Item Name: Crosstube Aft

DART AEROSPACE LTD		Work Order:	95456
Description: Crosstube High Aft (205/212)		Part Number:	D212-664-201
Inspection Dwg: D212-664-241 Rev: D		Page 1 of 1

DART SERVICE INSTRUCTION

DRAWING NO. D212-664-241	TITLE CROSSTUBE ASSY (205/212 HI AFT)	REV. D	DART AEROSPACE LTD ENGINEERING ORDER		D.E.O. NO. D212-664-241-D-1	SHEET NO. SHEET 1 OF 2	SCALE NTS
DRAWN	CHECKED	MFG. APPR.	APPROVED	DE APPR.			
DATE 11.04.07	DATE 11.04.11	DATE 11.04.12	DATE 11/04/12	DATE 11.04.12

FIGURE 1: SUPPORT INSTALLATION

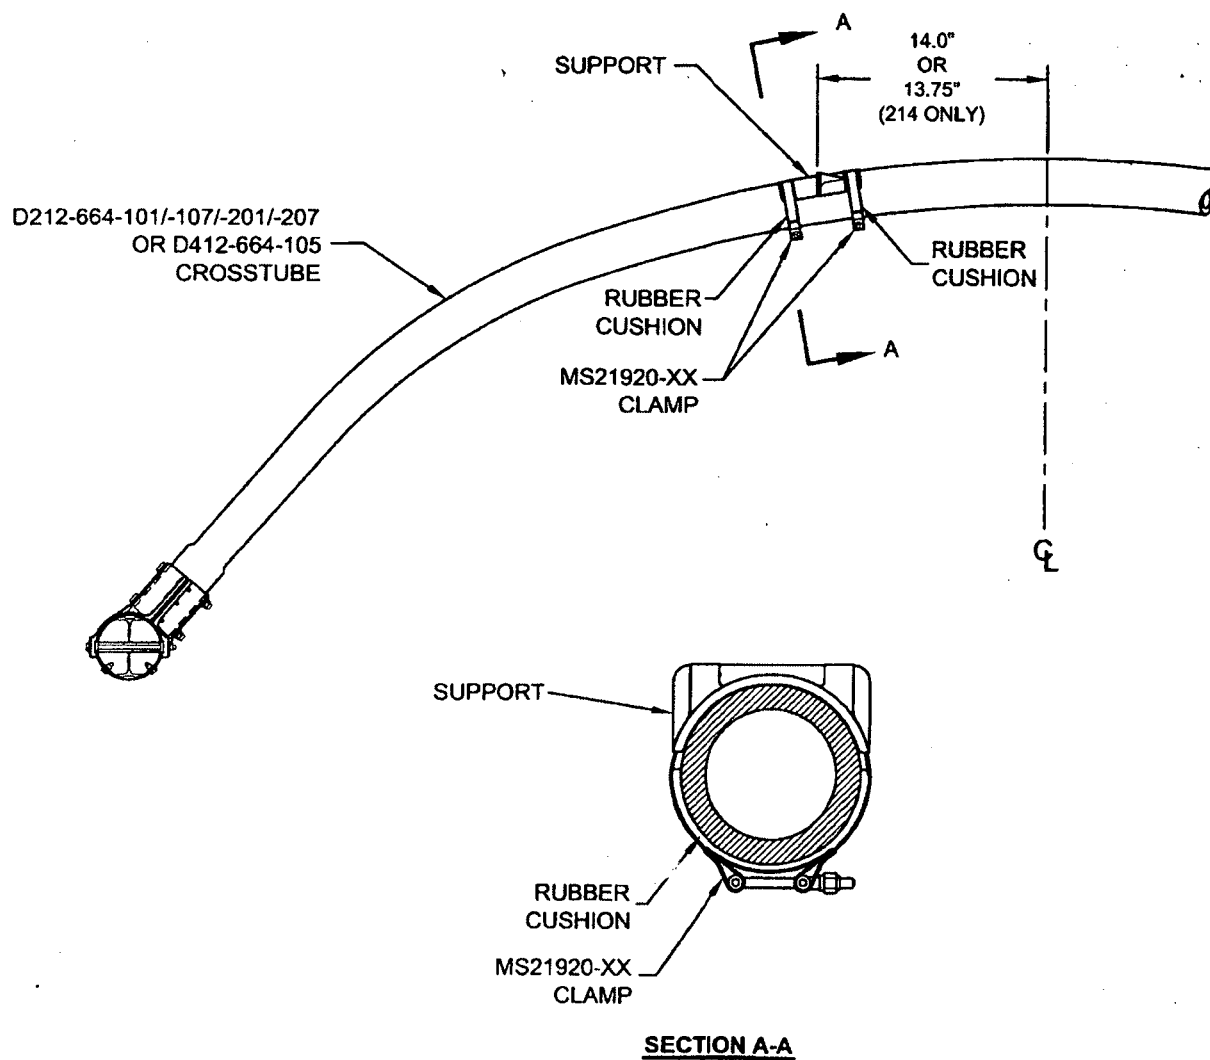
The supports on the following crosstubes are now installed using Proseal instead of Magnobond:

For the crosstubes listed above, section 32.4 of ICA-D212-664 is amended as follows. Use Figure 1 of this service instruction and Figures 32-2 to 32-9 of ICA-D212-664 for further reference. For crosstubes of an earlier change number, it is recommended that if the supports are removed, the supports should be reinstalled using the procedure listed below.

- 32.4.5 Apply a 0.04" to 0.07" thick layer of Proseal 890 Class B or AMS-S-8802 Class B sealant underneath applicable support and install support as shown in Figure 1 of this service instruction.

- 32.4.6 Install the clamps opposite to crosstube support as shown in section A-A of Figure 1. Install rubber cushions underneath each clamp around the bottom circumference of the crosstube up to the crosstube centerline. Torque clamps 80-100 in-lb (9.0-11.3 Nm). It is acceptable to use smaller or larger sized MS21920-XX clamps than those listed in ICA-D212-664, ensure that after torquing the clamps per this instruction, the nuts are in safety but not bottomed out

D212-664-241/-241B
ASSEMBLY DETAIL

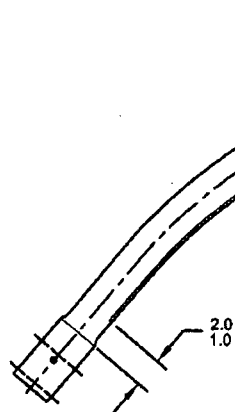
ADD AN INSPECTION WINDOW TO UNDERSIDE OF CROSSTUBE.

NOTES 2 OF SHEET 1 IS AMENDED AS FOLLOWS:

- 2) FINISH: CHEMICAL CONVERSION COAT PER DART QSI 005 4.1
PRIME INSIDE AND OUTSIDE PER DART QSI 005 4.2
MASK UNDERSIDE OF CROSSTUBE AS SHOWN (HATCHED AREA) AND
PAINT OUTSIDE PER DART QSI 005 4.2
REMOVE MASKING AND APPLY CLEAR COAT

MASK AREA PRIOR TO PAINTING.
REMOVE MASKING AFTER PAINT
AND APPLY CLEAR COAT

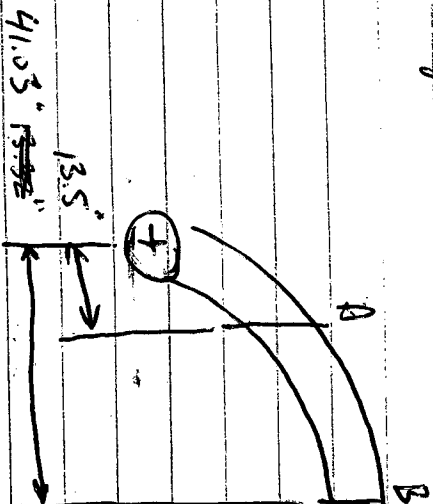
REPLACE MAGNOBOND WITH PROSEAL.

NOTE 12 & 15, SHEET 1 IS AMENDED AS FOLLOWS:

- 12) TO INSTALL D2940-1 SUPPORT: ABRASE MATING SURFACE OF SUPPORT AND CROSSTUBE WITH 180-GRIT SANDPAPER AND REMOVE RESIDUE WITH MEK (OR EQUIVALENT). APPLY A 0.04" TO 0.07" THICK LAYER OF PROSEAL 890 CLASS B-2 (OR AMS-S-8802 CLASS B-2) SEALANT TO MATING SURFACE OF SUPPORT.
- 15) TORQUE CLAMPS 80 TO 100 IN-LB. ENSURE AT LEAST 1.5 THREADS SHOWING IN SAFETY AND THAT NUT HAS NOT BOTTOMED-OUT AFTER TORQUING. **PRIOR TO PACKAGING, RE-CHECK TORQUE ON CLAMPS AFTER PROSEAL 890 SEALANT HAS CURED FOR 72 HOURS.**
